PRELIMINARY
 FOREST
 CONSERVATION
 PLAN

MID-COUNTY RECREATION CENTER
 SILVER SPRING, MARYLAND

SUBJECT: Mandatory Referral for Mid-County Recreation Center, Silver Spring

SUBJECT: Mandatory Referral No. 05504-DPWT-1
Mid-County Community Recreation Center
Aspen Hill Policy Area

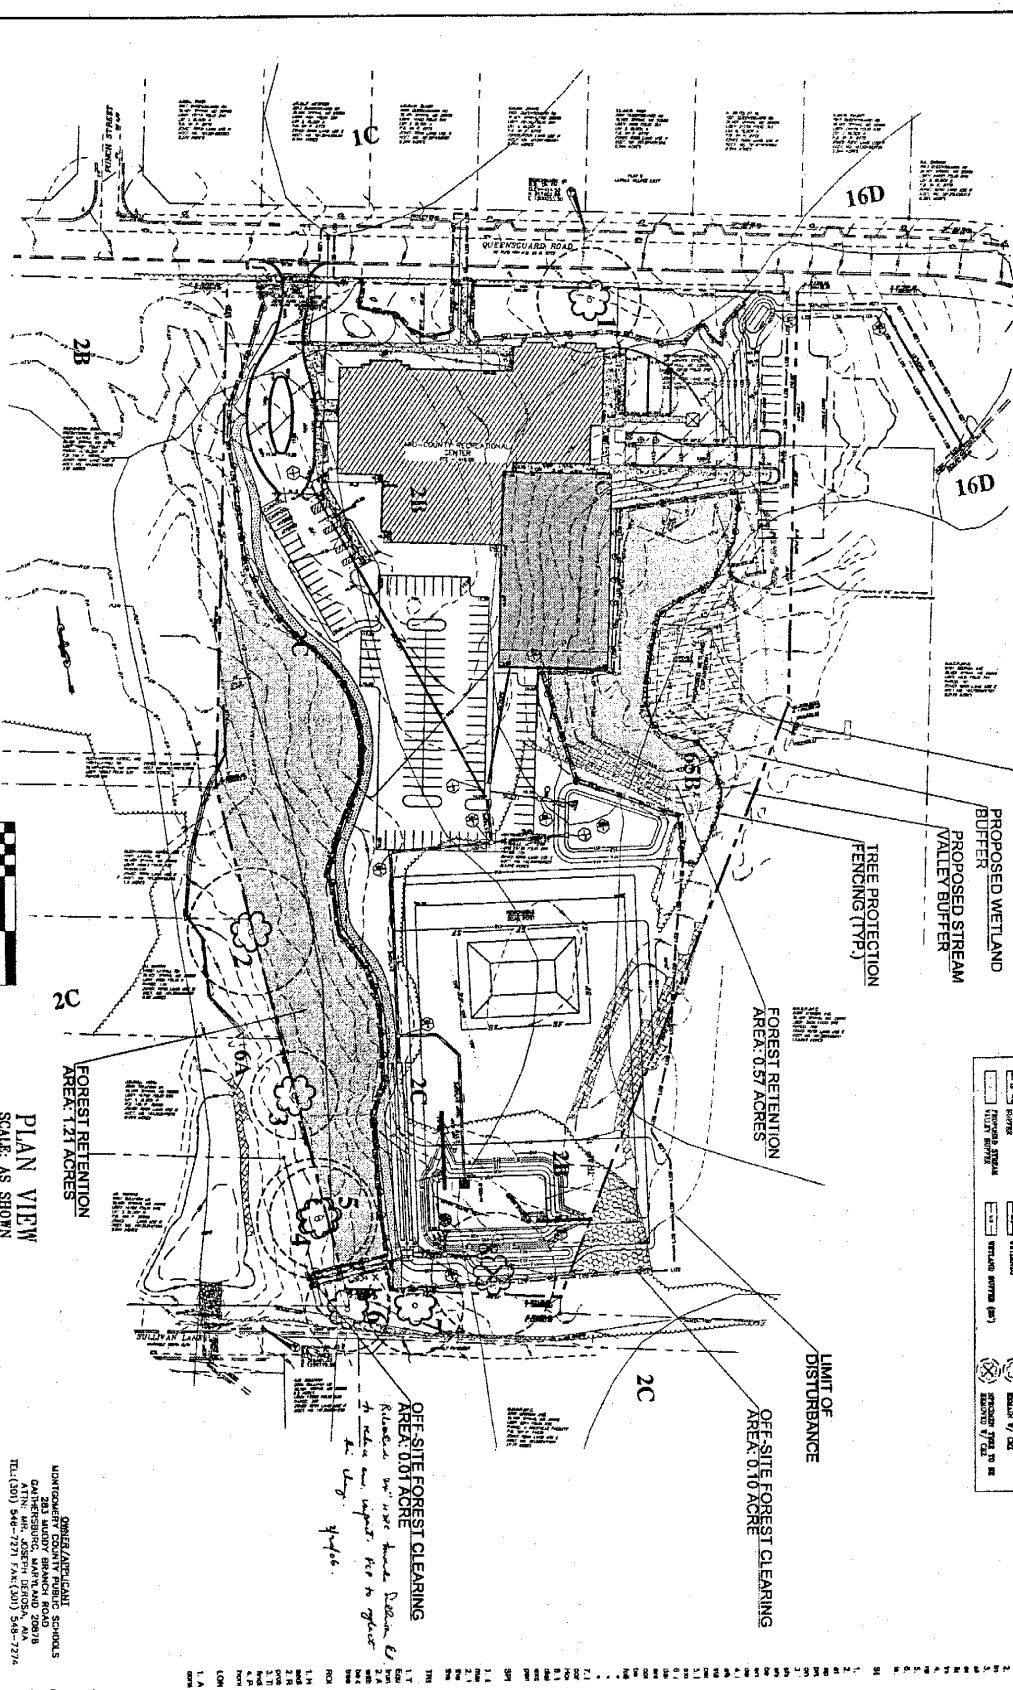
The site has an approved Natural Resources Inventory/Forest Stand Delineation (NRI/FSD) (No. 4-05237) approved in June 2005. Environmental Planning staff has reviewed the preliminary forest conservation plan submitted for the project. That plan shows 4.92 acres of the site's 6.65 acres of forest being cleared. The Conservation Threshold (e.g. minimum retention area) for the site is 1.86 acres. By retaining 1.73 acres of forest onsite and planting an additional 1.27 acres offsite the site will meet the requirements of forest conservation law. Staff has provisionally approved the preliminary forest conservation plan.

Contrary to the Environmental Guidelines (*Guidelines for Environmental Management of Development in Montgomery County*) the Development Plan shows approximately 3,300 s.f. of wetlands buffer being taken up by the proposed hard surface play area. Additionally, Environmental Planning Staff is concerned over the effect that the proposed retaining wall and upgrade development will have on the continued survival of the wetlands post development, when contributing flows are cut off or diverted. The Park and Planning Department evaluates proposed wetland impacts under federal and State avoidance guidelines that are listed as avoidance, minimization, and mitigation. The applicant was very responsive to Staff suggestions to develop avoidance options that did not encroach into wetlands or wetlands buffer areas. However, the applicant has not accepted these alternative designs because of the reduction in hard-surface play area and/or the number of parking spaces, and because of safety concerns

The applicant has offered to remove the existing basketball court on their site and restore the wetlands at that location, and create an additional 0.26 acres of wetlands, as part of the mitigation for encroaching into the wetland buffer. This action will result in a slight loss of buffer area but a net gain of wetlands area on the site. Staff believes that this is adequate mitigation for the proposed encroachment.

ATTACHMENT A

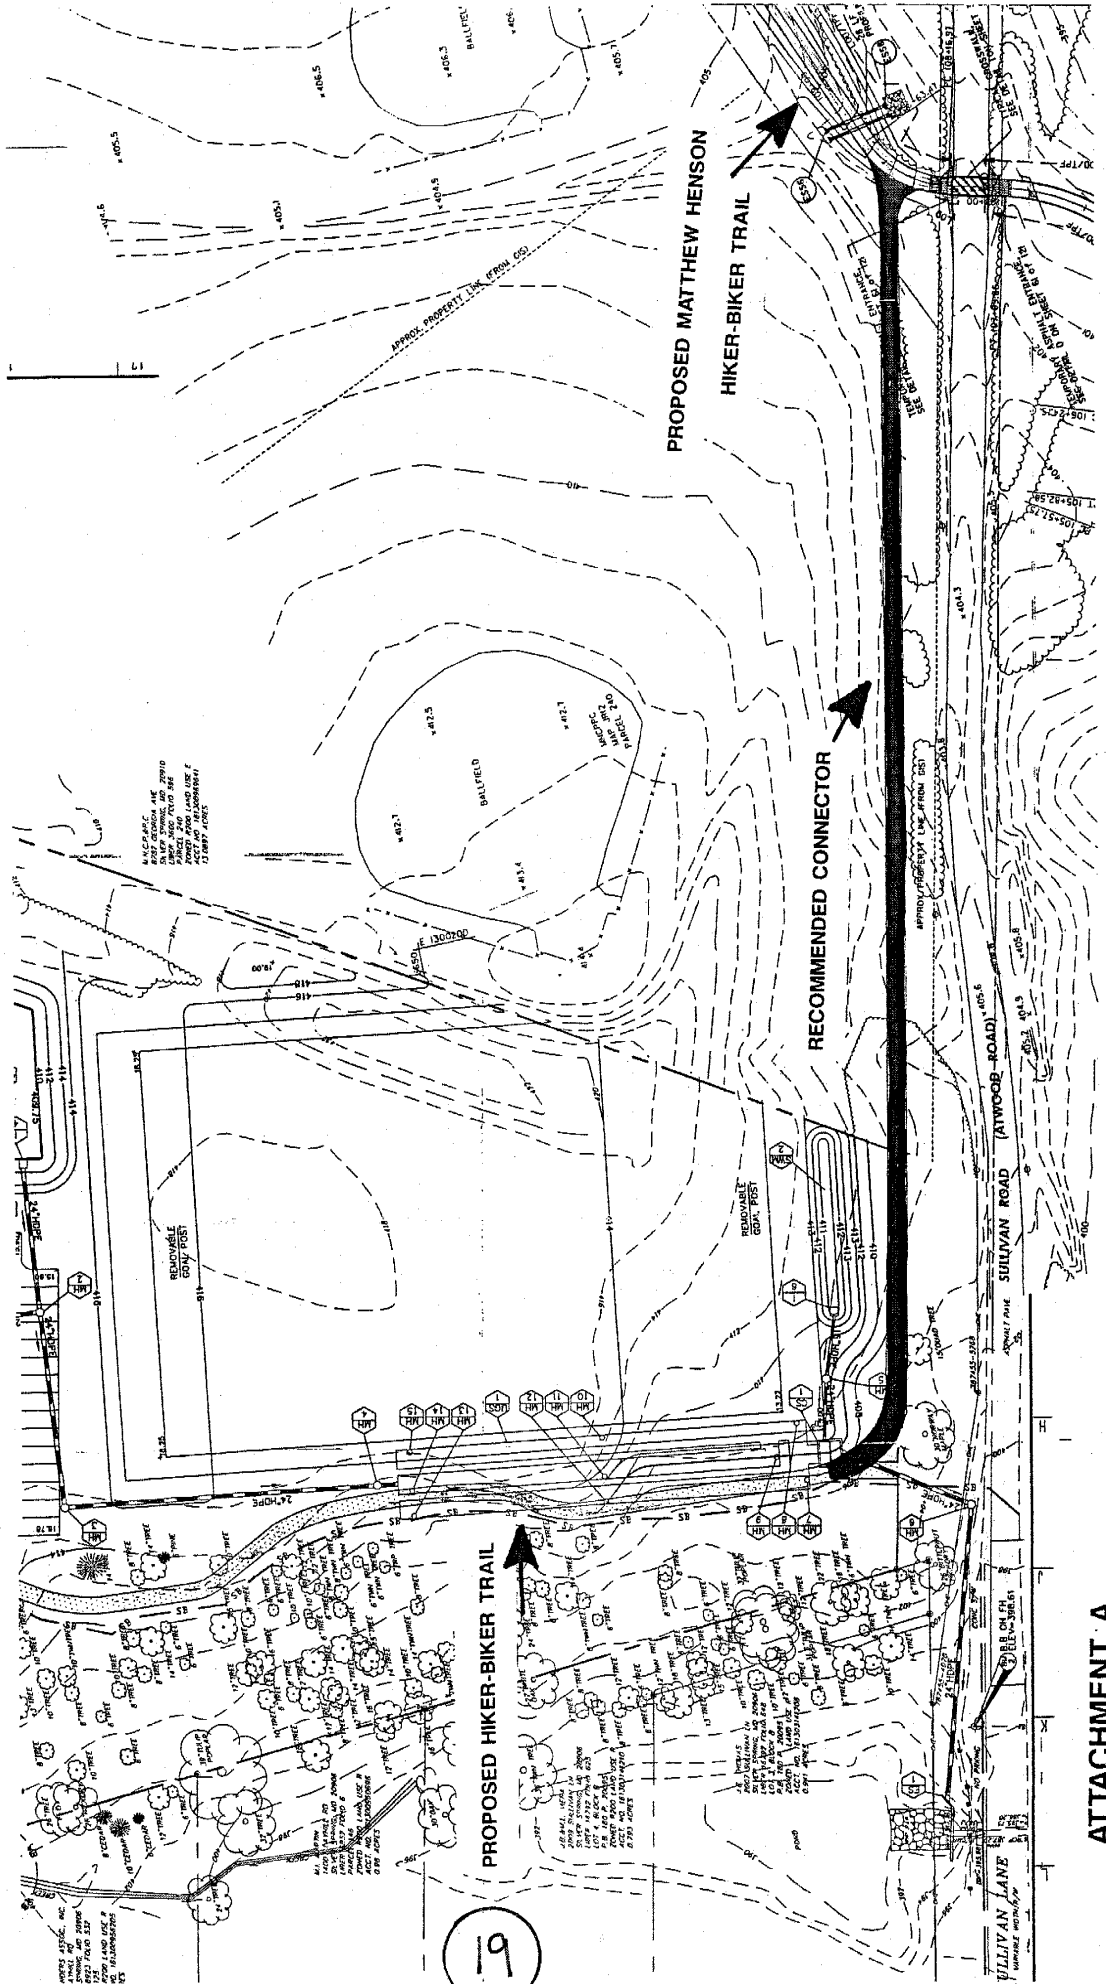
1. The southern terminus of the trail should extend to connect to the future Matthew Henson Hiker-Biker Trail located in Layhill Village Park. Matthew Henson Trail provides the only safe crossing of Sullivan Lane to the south. A proposed plan of the connection to the Matthew Henson Trail is attached (Attachment A).

2. As the trail travels north along the southern parking lot, it should cross between the narrow connections of the two lots. A cross walk should be provided at that location. This point provides the least pedestrian vehicle conflict. At that point, it can connect to the sidewalk in front of the recreation center. This allows the section of trail along the northern parking lot to be removed. Signs should be provided to direct bicycle traffic to the bike route on Queensguard Road. A plan of the northern connection to the recreation center is attached (Attachment B).

3. The sidewalk in front of the recreation center should be widened to 8 feet.
4. A park permit is required from M-NCPPC for construction of the athletic field or any other construction activity on park property.
